# Access Compliance Report

## Public Rights-of-Way

### (Curb Ramps)

Intersection ID: 5175	Main Street: FROSTMOOR_PL	Cross Street: HAYBRIDGE_RD	Location: SE
ADA ID: 6B1DB75DBCB2	Ramp Type: Perp	Initial Pass/Fail: Fail	Overall Compliance: No
Severity Score: 46.25			
Codes/Mitigation Info/Possible Solution		Field Measurements/Component Compliance

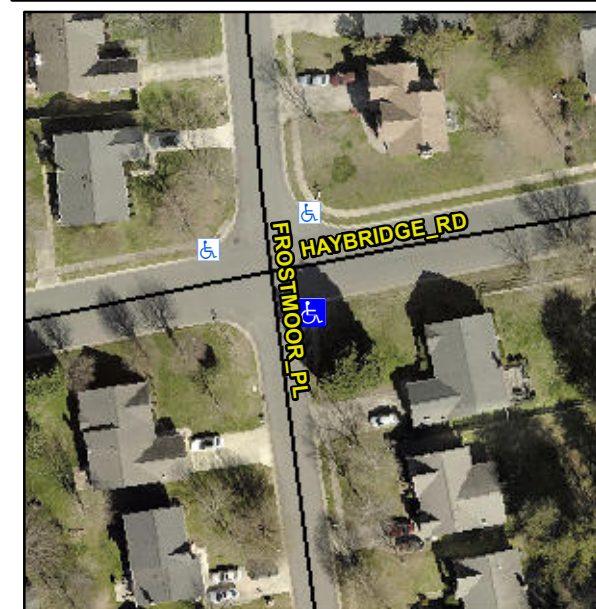
**R304.5.1, R304.2.2, R304.5.3**

Compliance	Description	Data	Compliance	Description	Data
N/A	Ramp Length (in)	51.0	No	Ramp Slope (%)	9.2
No	Ramp Width (in)	47.0	No	Ramp XSlope (%)	8.5
N/A	Flare Type LT	N/A	N/A	Flare Type RT	N/A
N/A	Flare Slope LT (%)	N/A	N/A	Flare Slope RT (%)	N/A
N/A	Flare Traversable LT?	N/A	N/A	Flare Traversable RT?	N/A
N/A	Landing Length (in)	N/A	N/A	DWS Provided?	N/A
N/A	Landing Width (in)	N/A	N/A	DWS Contrast?	N/A
N/A	Landing Slope (%)	N/A	N/A	DWS Length (in)	N/A
N/A	Landing X Slope (%)	N/A	N/A	DWS Full Width?	N/A
N/A	Landing Curb? (Y/N)	N/A	N/A	DWS Offset (in)	N/A
N/A	Shared Landing?	N/A			
N/A	Gutter Ponding?	N/A	N/A	Gutter Slope (%)	N/A
N/A	Gutter Lip Ht (in)	N/A	N/A	Gutter X Slope (%)	N/A
N/A	Painted X Walk1?	No	N/A	Painted X Walk2?	N/A
	X Walk 1 Direction	To N		X Walk 2 Direction	N/A
N/A	X Walk 1 Width (in)	N/A	N/A	X Walk 2 Width (in)	N/A
	X Walk 1 Slope (%)	1.2		X Walk 2 Slope (%)	N/A
	X Walk 1 X Slope (%)	5.8		X Walk 2 X Slope (%)	N/A

**Remove & Replace Entire Ramp.**
